**Lindfield Learning Village**

Traffic and Transport Assessment -  
SEARs Comment Response

Issue | 20 November 2017

Job No <b>251272</b>	Drawing No <b>SKT009</b>	Issue <b>A</b>
-------------------------	-----------------------------	-------------------

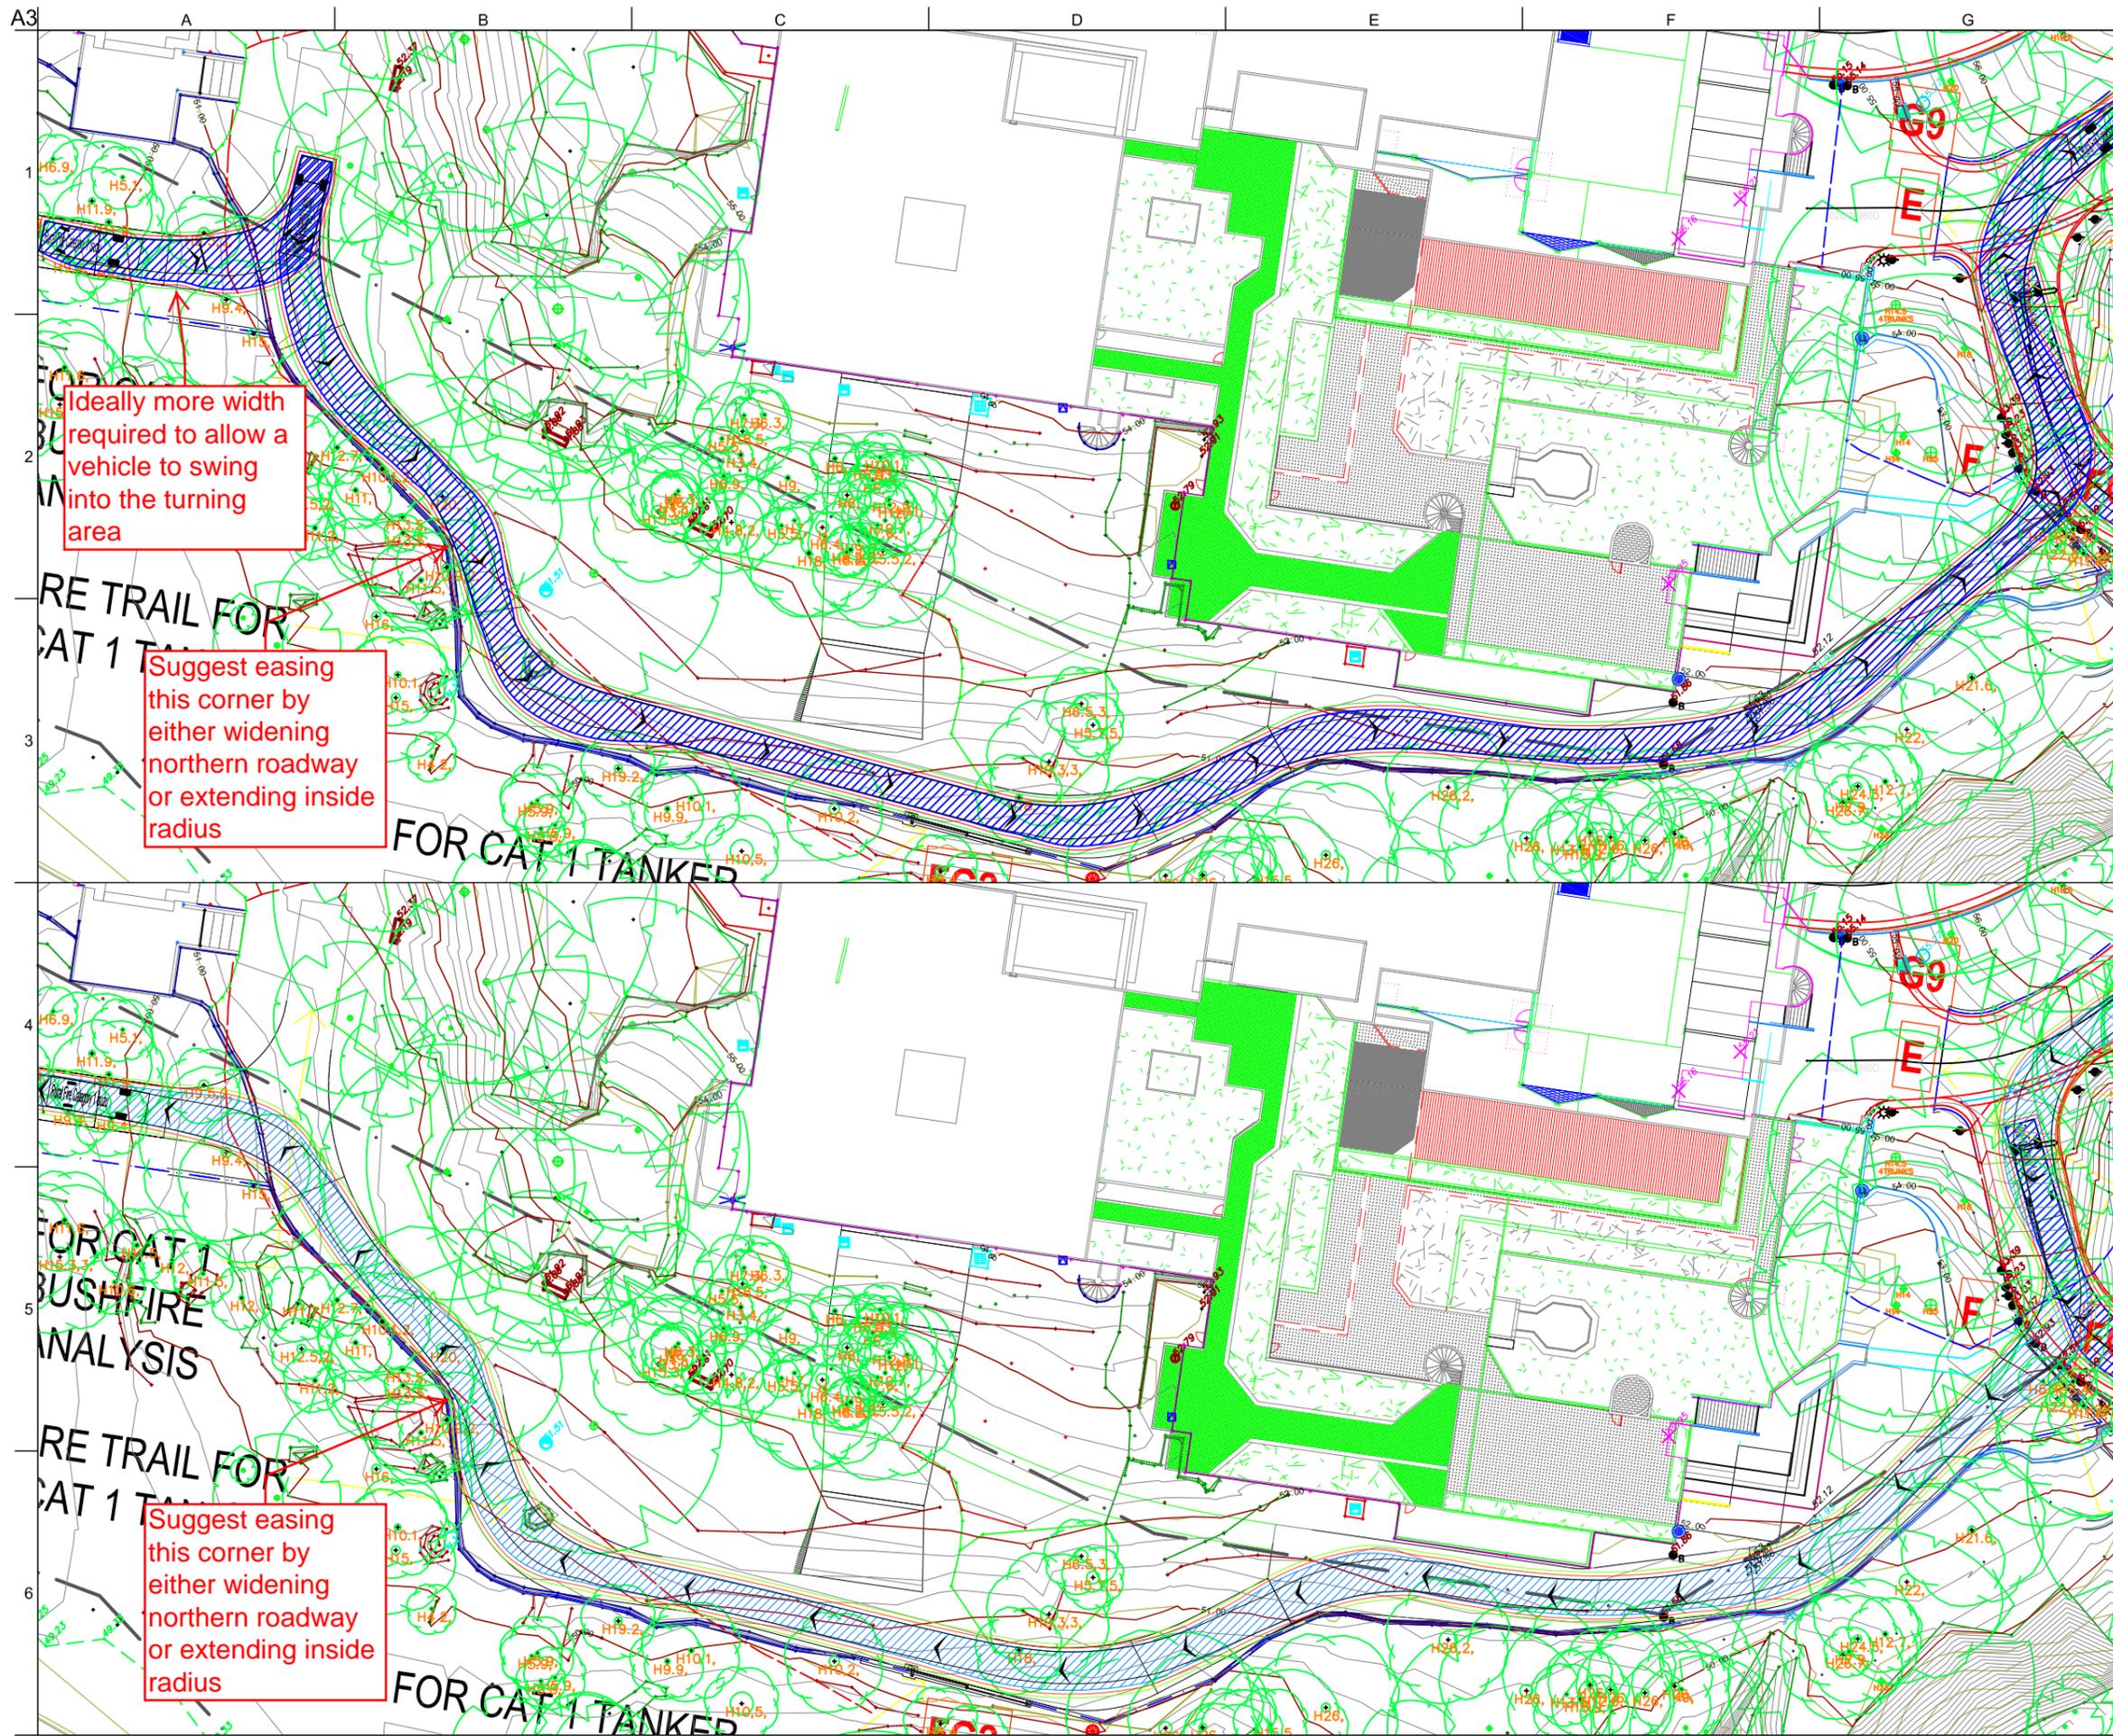
Ideally more width required to allow a vehicle to swing into the turning area
